The Commission has issued the enclosed Amendment No. 51 to Facility Operating License No. DPR-24 and Amendment No. 57 to Facility Operating License No. DPR-27 for the Point Beach Nuclear Plant, Unit Nos. 1 and 2, respectively. The amendments consist of changes to the Technical Specifications in partial response to your application transmitted by letter dated March 31, 1981.

WISCONSIN ELECTRIC POWER COMPANY

POINT BEACH NUCLEAR PLANT, UNIT NO. 1

SAFETY EVALUATION BY THE OFFICE OF NUCLEAR REACTOR REGULATION
SUPPORTING AMENDMENT NO. 53 TO FACILITY OPERATING LICENSE NO. DPR-24
AND AMENDMENT NO. 57 TO FACILITY OPERATING LICENSE NO. DPR-27

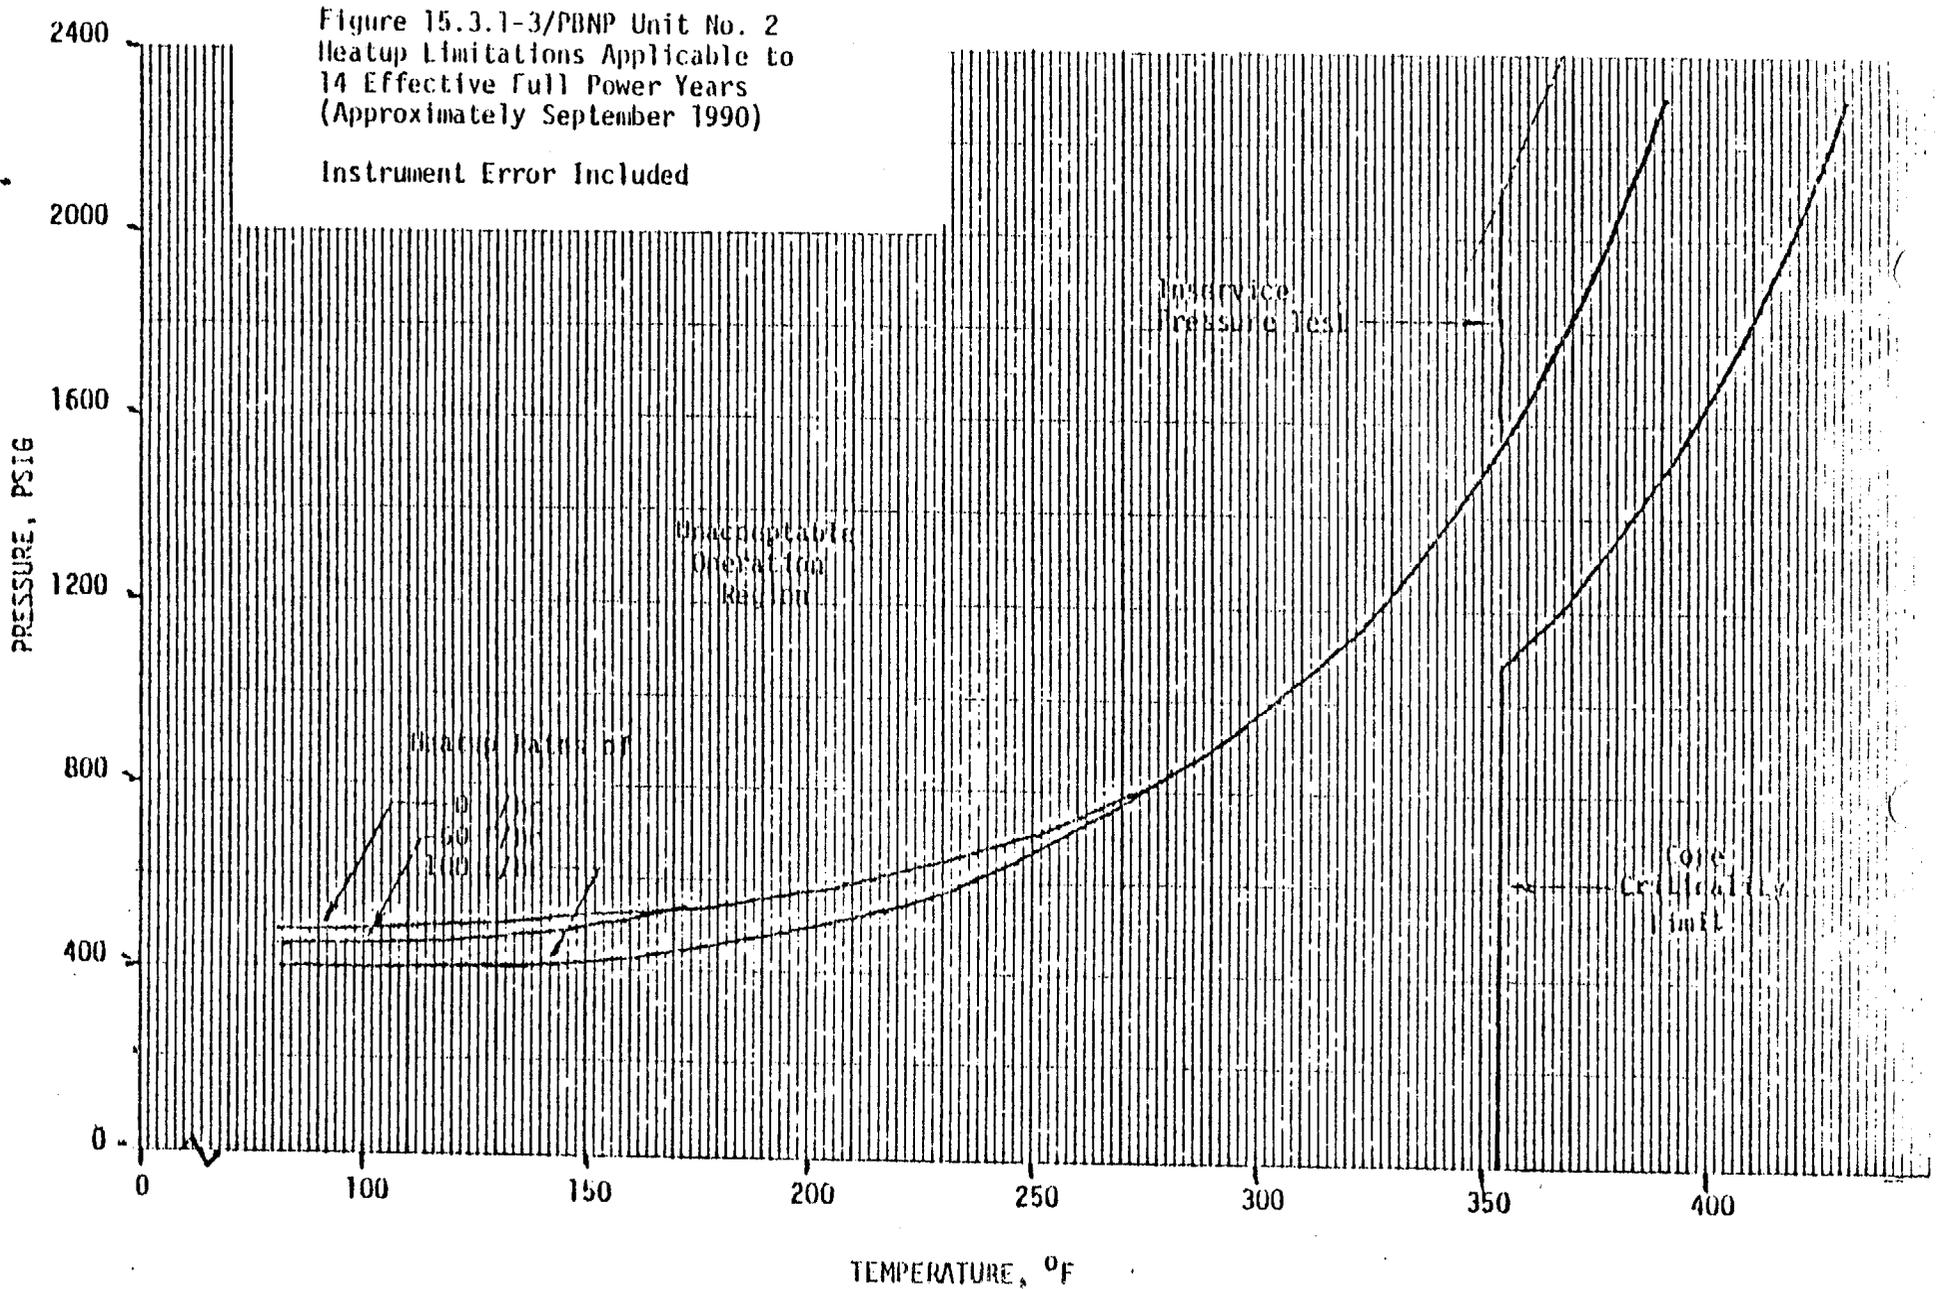
15.3.1-7
15.3.1-8a
15.3.1-17
Table 15.3.1-2
Figure 15.3.1-3
Figure 15.3.1-4

The heatup and cooldown curves presented in Figures 15.3.1-1 and 15.3.1-2 (Unit 1) and 15.3.1-3 and 15.3.1-4 (Unit 2) were calculated based on the above information and the methods of ASME Code Section III (1974 Edition) Appendix G, "Protection Against Nonductile Failure", and are applicable up to the operational exposure indicated on the figures. Corrections for possible instrumentation inaccuracies have been incorporated into these curves. The temperature correction is made by adding the temperature error (24°F, Unit 2) to the required temperature and the pressure correction is made by subtracting the pressure error (64 psi, Unit 2) from the required pressure. These corrections adjust the curves in the conservative direction.

The proposed revisions in the heatup and cooldown limitations for Units 1 and 2 are based on methods and data provided in Westinghouse Electric Corporation Topical Reports WCAP-8743 and 8738 respectively. The revised temperature and pressure curves are to be applicable through fourteen (14) effective full power years (EFPY) of operation for Point Beach Unit 2 which is estimated to end in September 1990. The licensee stated that it is desirable for plant operational reasons that the temperature and pressure curves and heatup and cooldown limitations for both units be identical. Accordingly, the temperature and pressure limitations developed for Unit 2 for 14 EFPY are applicable to Unit 1 for 21.5 EFPY of operation.
